## **PROPOSED HOUSING DEVELOPMENT AT CLONBURRIS, DUBLIN**

### **Stage 1 Quality Audit**

**(Incorporating a DMURS Street Design Audit, and Audits  
of Accessibility, Cycling, Walking and Road Safety)**

Project Title	Proposed Residential Development at Clonburris, Dublin
Project No.	24050-01
Client	Malone O'Regan
Document Title	Stage 1 Quality Audit
Document No.	24050-01-001

**Figure 5.1 – Restricted Visibility Splays**

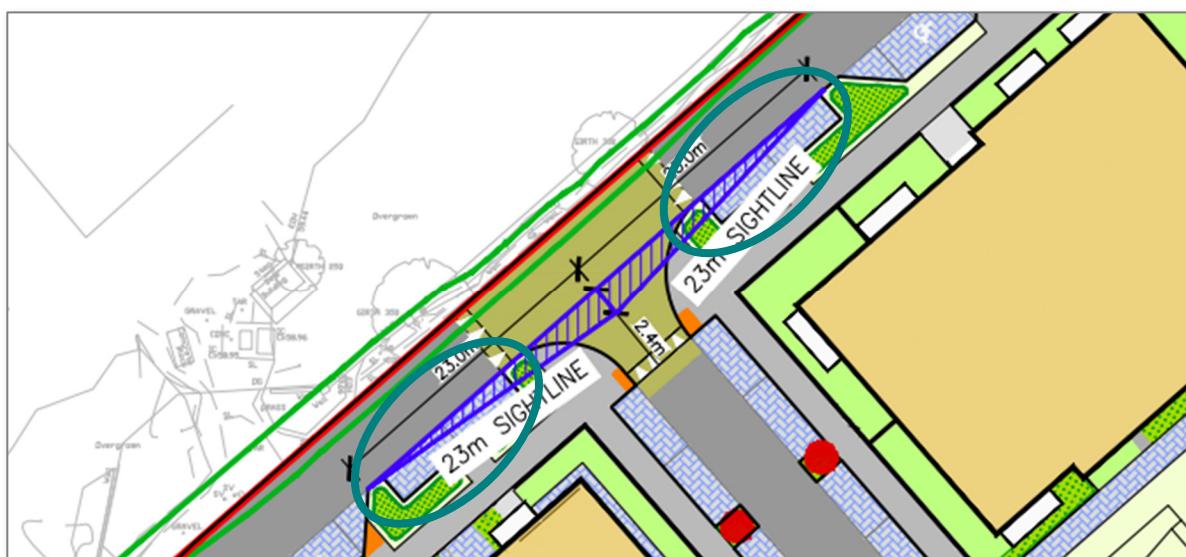
Sightlines at the priority junction in Figure 5.1 may be restricted by vehicles parked in the adjacent parking spaces. This may increase the likelihood of vehicle collisions due to the reduced sightlines created by parked vehicles on either side of the junction.

Ensure adequate visibility splays at all junctions from edge of carriageway. Remove parking bays or any other obstructions from visibility splays.

5.1	Yes	Yes		
5.2	Yes	Yes		
5.3	Yes	Yes		
5.4	Yes	Yes		
5.5	Yes	Yes		
5.6	Yes	Yes		
6.1	Yes	Yes		
6.2	Yes	Yes	Third-party land is not owned by the developer. The SDZ development establishes the street hierarchy and specifically outlines connectivity with both the station and the proposed development.	The proposed development includes a footpath that will connect to future paths leading to the Kishogh railway station once they are constructed by others.

**Figure 5.4 – Traffic Signs adjacent to Kerbline**

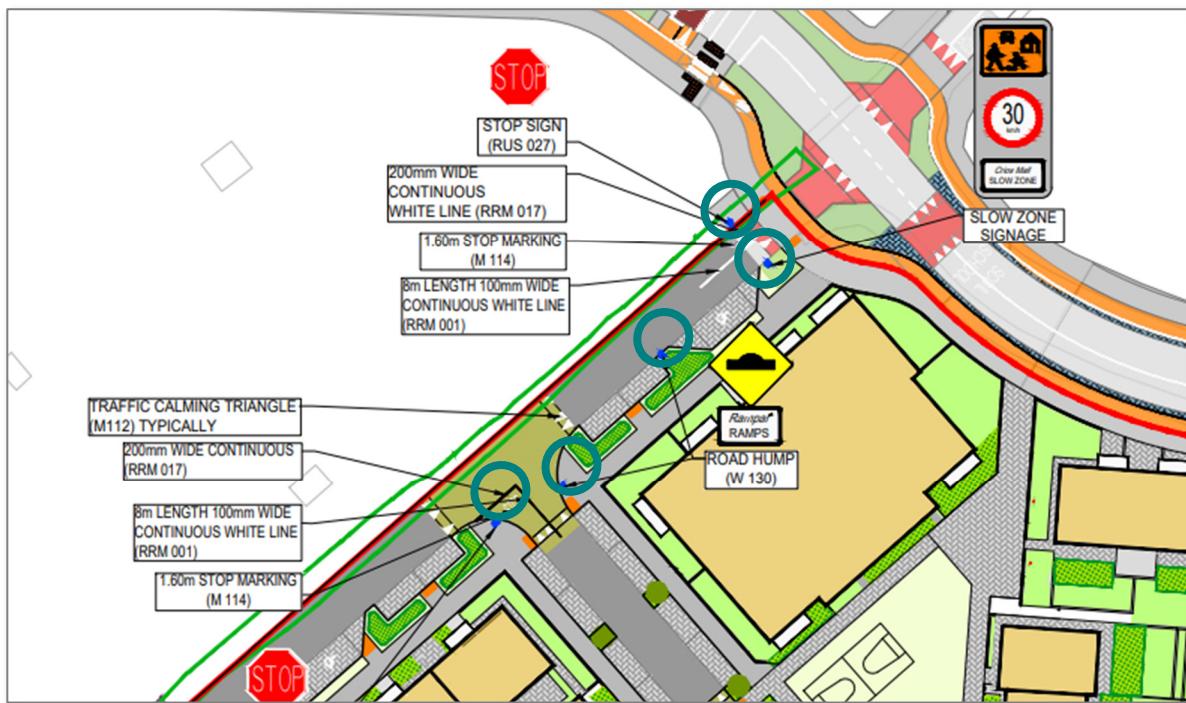
Some proposed traffic signs feature poles which appear to be located on the kerbline. This may result in an increased likelihood of large vehicles swerving to avoid them, resulting in collisions with oncoming vehicles, or vehicles striking the overhanging signs and twisting them, making the signs ineffective which may cause driver confusion and/or collisions.

Ensure adequate distance between vehicles, and their mirrors, and signage throughout the development. Review in conjunction with swept path analyses.

**Figure 6.1 – Inconsistent junction treatment**

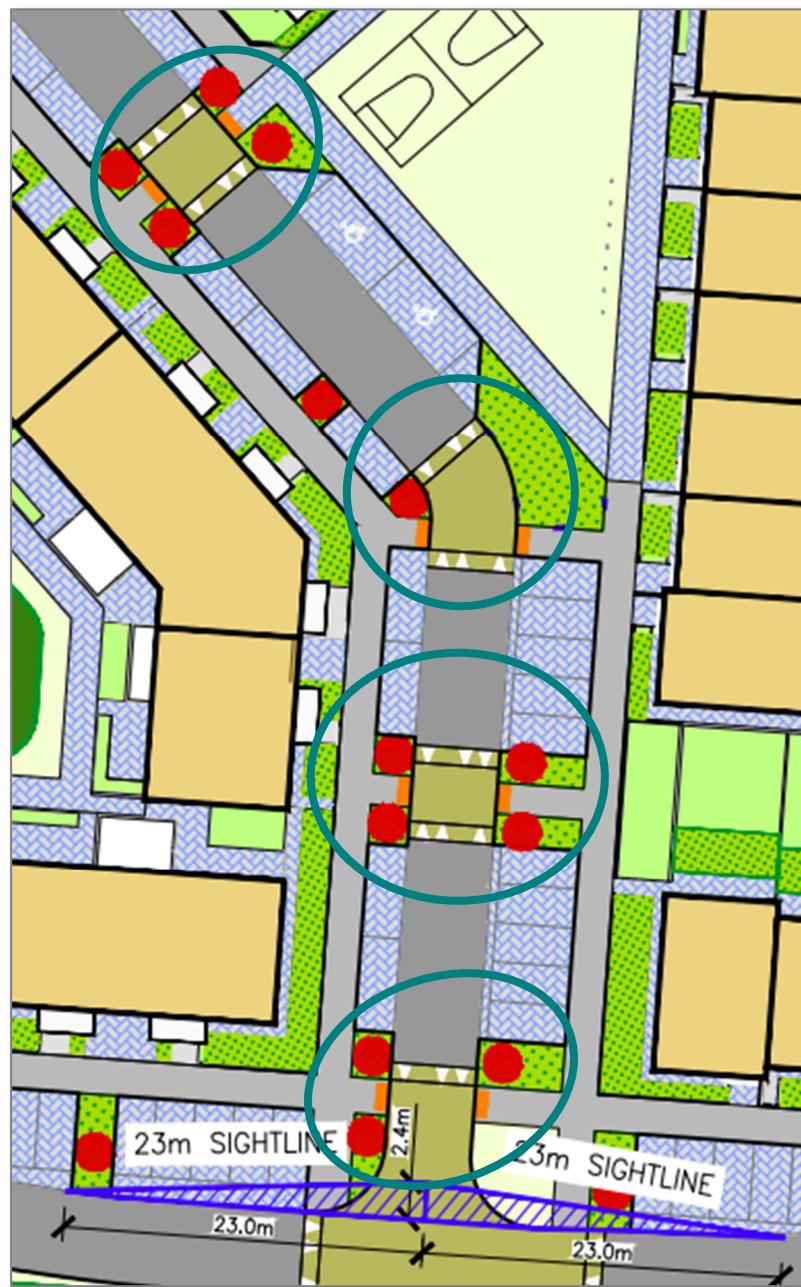
Inter-visibility between pedestrians and drivers at raised crossings (e.g. Figure 6.1) in the proposed development may be significantly compromised by the proposed parking arrangement and tree locations. This may increase the risk of collisions and pedestrian injuries at these locations.

Ensure adequate inter-visibility between pedestrians and drivers at pedestrian crossings.
